**DEPARTMENT OF TRANSPORTATION  
STATE OF GEORGIA**

**FILE:** MSL00-0004-00(403), Cobb County  
P.I. No.: 0004403  
SR 3 Connector at SR 120 Alternate

**SUBJECT: IMPLEMENTATION OF VALUE ENGINEERING STUDY ALTERNATIVES**

**SUBJECT:** Value Engineering Study - Responses

PLAN AND PROFILE OF PROPOSED  
SR 3 CONNECTOR @ SR 120 ALT INTERCHANGE  
COBB COUNTY  
MSL00-0004-00(403)

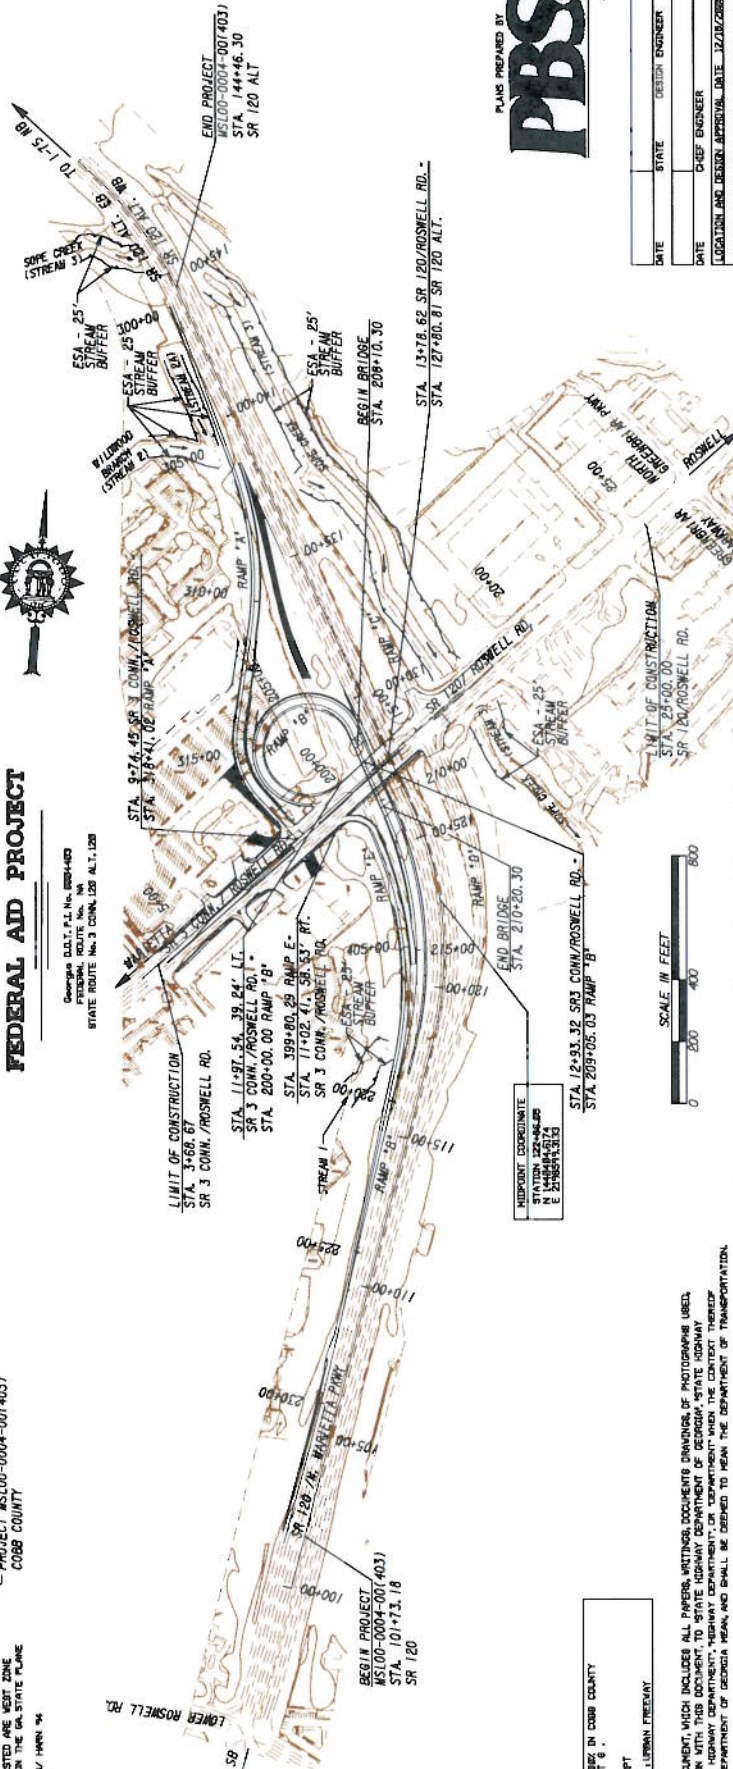
PI No. 0004403: -ALT. No. B-1, we need an up to date memo approving the pavement design for each ramp or comply with the recommendation, provide separate designs for each ramp.

The AADT values on the cover sheet for ramps A, B & E are 7500, 16500, and 900, respectively. The VE team used values of 3750, 7750, and 450 presumably because the paving design software requires the use of 1-way AADT values. However, because these are on- and off-ramps, the values listed on the cover sheet are in fact 1-way AADT values. Thus the pavement design suggested by the VE team would be inadequate to support the appropriate travel load and the cost savings could not be realized. Using the correct traffic data (7500 for ramp A), the pavement is 2.8% under designed. Any change to the pavement thickness would push this value outside of the acceptable 0-5% under designed recommendation for urban sections.
